Date: December 3, 2017
To: Mayor John Tory and Councillors, City of Toronto
Cc: City Clerk, City of Toronto
Geoff Cape, CEO, Evergreen
From: Walk Toronto (Steering Committee)
Re: 2017.PW24.5, Speed Limit on Bayview Avenue from Pottery Road (Northerly Intersection) to River Street Ramp

Date: October 17, 2017
To: Public Works and Infrastructure Committee (PWIC), City of Toronto
Cc: Councillor Jon Burnside (Ward 26)
Councillor Kristyn Wong-Tam (Ward 27)
Executive Assistant Tom Davidson (Ward 28)
Councillor Mary Fragedakis (Ward 29)
Geoff Cape, CEO, Evergreen
From: Walk Toronto (Steering Committee)
Re: 2017.PW24.5, Speed Limit on Bayview Avenue from Pottery Road (Northerly Intersection) to River Street Ramp

Clockwise, from top left:

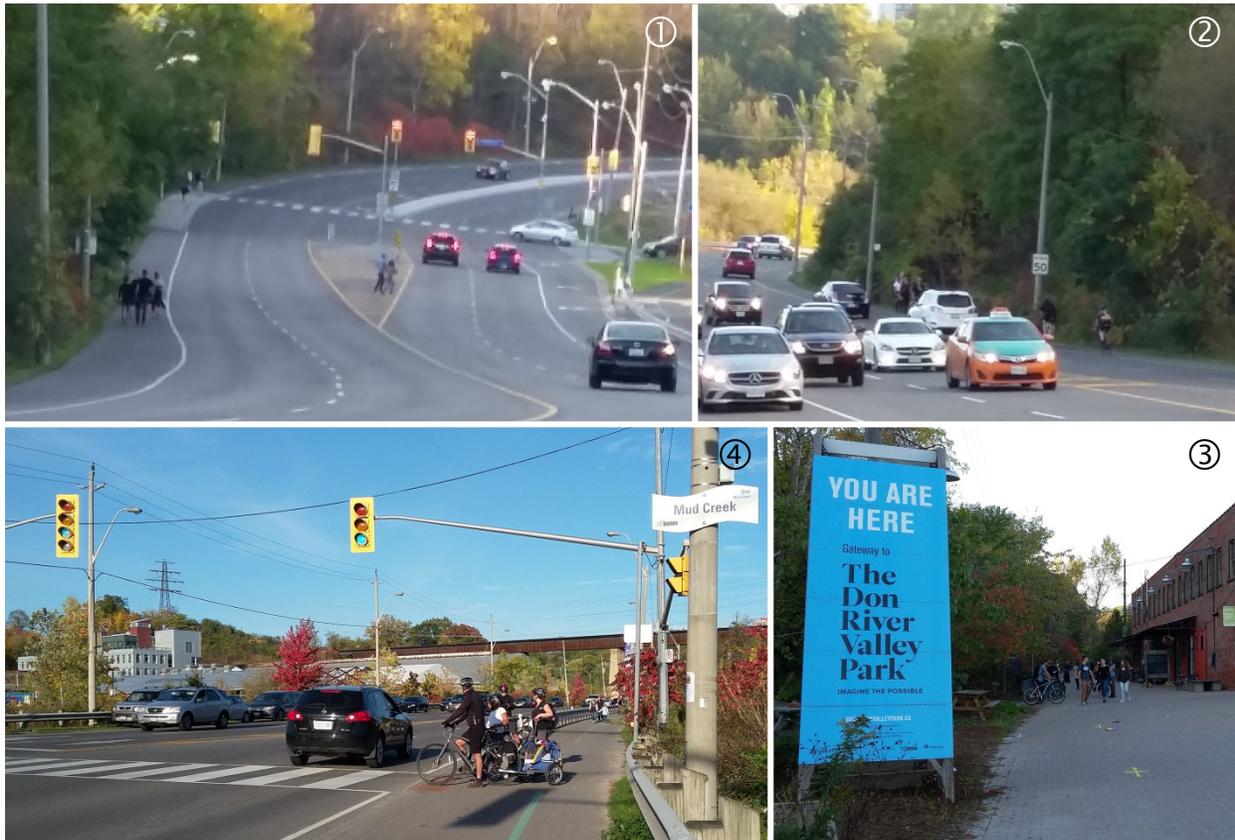
- (1) *View north on Bayview Avenue, at Pottery Road (south) intersection:* People are walking along the west shoulder of Bayview Avenue, and others cross Bayview during a break in traffic before they reach the intersection crosswalk. The west shoulder provides a more direct and closer access to the north entrance to the Evergreen Brick Works site; the crosswalk markings, located only on the north side of this intersection, require that people divert from their intended destination and travel farther.

- (2) *View south on Bayview Avenue, from Pottery Road (south) intersection:* People are cycling southbound along the west shoulder, heading towards people walking northbound in the same shoulder, right next to which are motor vehicles. The posted 50 km/hr speed limit would be raised back up to 60 km/hr under the PWIC recommendation.

- (3) *At the Evergreen Brick Works site entrance:* Don River Valley Park signage, suggesting that we “imagine the possible.” Increasing the speed limit on the street that runs through the entire length of the super park will make it more difficult to realize the full potential of one of the largest bodies of green space in the vicinity of our parkland-deficient downtown.

- (4) *View north on Bayview Avenue, at Evergreen Brick Works main (south) entrance:* Adults and children, on bikes and in bike trailers, wait in the multi-use trail on the east side of Bayview to cross at the traffic lights. While this multi-use trail has a guiderail crash barrier outside of the intersection, the trail does not receive winter maintenance and is not lit at night (a section of the trail diverges from the roadway and therefore will not receive illumination from the roadway lighting).
